<b>DEVELOPMENT NO.:</b>	24002719
<b>APPLICANT:</b>	Tom Vartzokas
<b>ADDRESS:</b>	98 ESPLANADE HOVE SA 5048
<b>NATURE OF DEVELOPMENT:</b>	Variation to development application 22026449 comprising the construction of a roof top terrace as a 4th building level
<b>ZONING INFORMATION:</b>	<p><b>Zones:</b></p> <ul style="list-style-type: none"> <li>• Waterfront Neighbourhood</li> </ul> <p><b>Overlays:</b></p> <ul style="list-style-type: none"> <li>• Airport Building Heights (Regulated)</li> <li>• Affordable Housing</li> <li>• Building Near Airfields</li> <li>• Coastal Flooding</li> <li>• Prescribed Wells Area</li> <li>• Regulated and Significant Tree</li> <li>• Stormwater Management</li> <li>• Urban Tree Canopy</li> </ul> <p><b>Technical Numeric Variations (TNVs):</b></p> <ul style="list-style-type: none"> <li>• Finished Ground and Floor Levels (Minimum finished ground level is 3m AHD; Minimum finished floor level is 3.25m AHD)</li> <li>• Minimum Frontage (Minimum frontage for a detached dwelling is 5m; semi-detached dwelling is 5m; row dwelling is 5m; group dwelling is 5m; residential flat building is 5m)</li> <li>• Minimum Site Area (Minimum site area for a detached dwelling is 300 sqm;

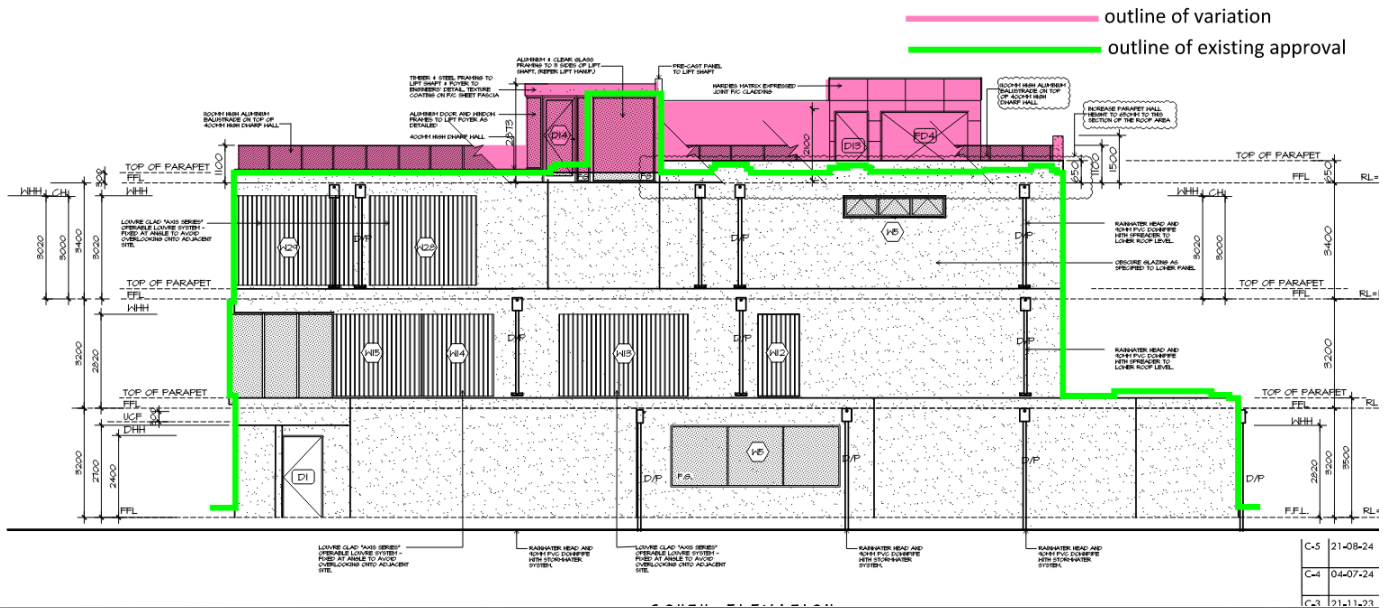
The 4<sup>th</sup> level enclosure is setback 8.9 metres from the southern side boundary and 15.7 metres from the eastern rear boundary, which on balance is a sufficient distance in offsetting overshadowing impacts.

The 4<sup>th</sup> level enclosure is setback 2.9 metres from the northern side boundary, although it should be setback 4.2 metres where following the relevant Designated Performance Feature 8.1 with respect to side setbacks. Of course being the northern elevation, there is no concern regarding overshadowing. Visually, the 4<sup>th</sup> level will be visible from the immediate northern adjacent property.

The proposed setbacks are considered reasonable on balance and satisfy Performance Outcomes 8.1 (side boundary setbacks) and 9.1 (rear boundary setbacks) whereby the 4<sup>th</sup> level wall is setback a sufficient distance to achieve separation between buildings that contributes to the suburban character and provides sufficient access to natural light and ventilation.

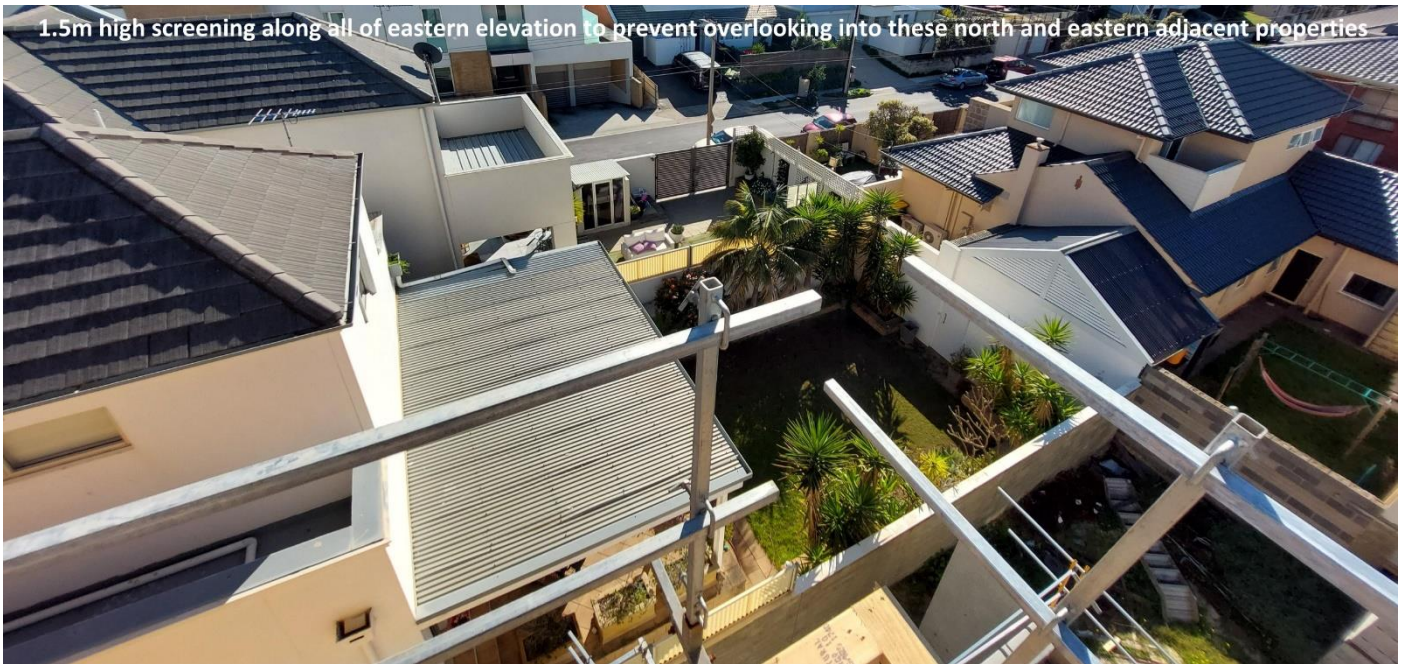
The 4<sup>th</sup> level terrace is setback 13.3 metres from the eastern rear boundary and therefore approximately 14 metres from the nearest habitable room window to the east. The terrace is located 2.9 metres from the northern side boundary and approximately 5 metres from the nearest habitable room window of the northern adjacent dwelling.

Although, numerically, the terrace screen should have a minimum height of 1.7 metres, the proposed screen height of 1.5 metres is considered satisfactory in the context of this proposal, as it is considered to reasonably mitigate direct overlooking, and is consistent with the minimum height of 1.5 metres, which would be required if the proposal involved a 4<sup>th</sup> level room window.

As per the photos below, it is clear that 1.5 metre high screening would be sufficient in addressing overlooking, particularly as these images show the 1.1 metre high temporary builders safety balustrade, which makes it clear that a 1.5 metre high fixed screen above the finished floor level, would obliterate all views of adjacent windows and yards.

The roof top terrace shall comprise fixed 1.5 metre high screening to the northern and eastern elevations and 650mm high screening to the southern elevation over a minimum continual length of 11.9 metres when measured from the eastern most point of the southern elevation prior to occupation.

*The red hashed area depicts the height of the 650mm parapet as measured on site to support this photographic illustration.*

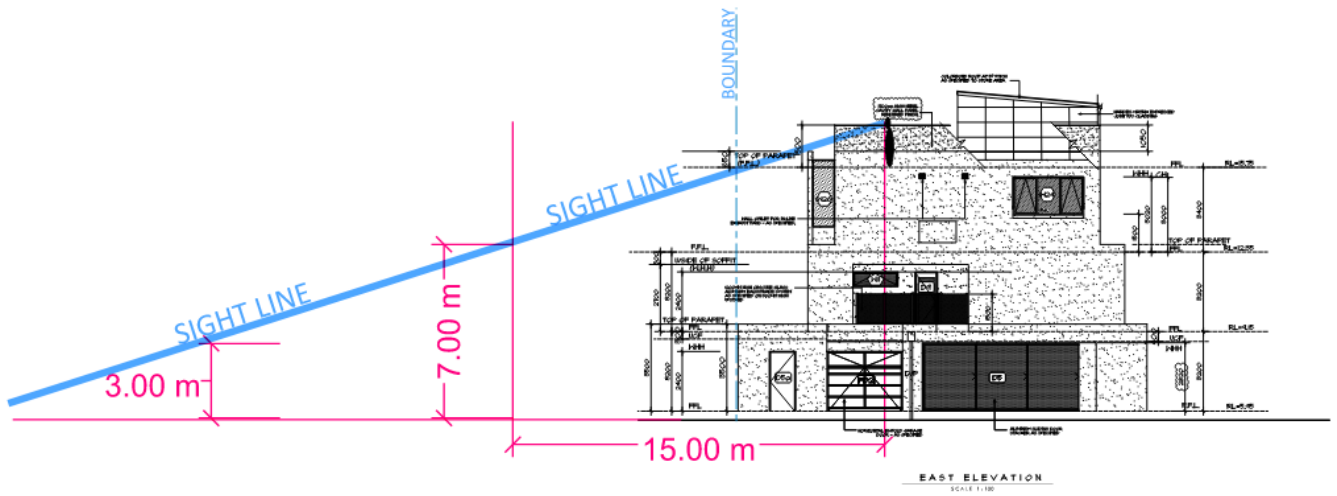
The southern elevation proposes a more unique screening solution on balance with sight lines and accessibility restrictions due to proposed safety balustrade in front of roof top solar panels and restricted accessibility beyond the solar panels. In effect, on the southern elevation, there will be 1.1 metre high safety balustrade in front of the roof top solar panels, which cannot be stood on. On the external building wall, a 650mm high parapet is proposed, which when considering the site line from the 1.1 metre high balustrade to top of 650mm parapet screen, will result in obstructed southerly views. This is illustrated using the photo and eastern elevation plan, below:

650mm high screening along southern elevation to prevent overlooking into these southern adjacent properties  
 1.1 high balustrade in position of camera. 650mm high screening not accessible as they sit beyond the solar panels

location of solar panels - cannot be accessed and stepped on
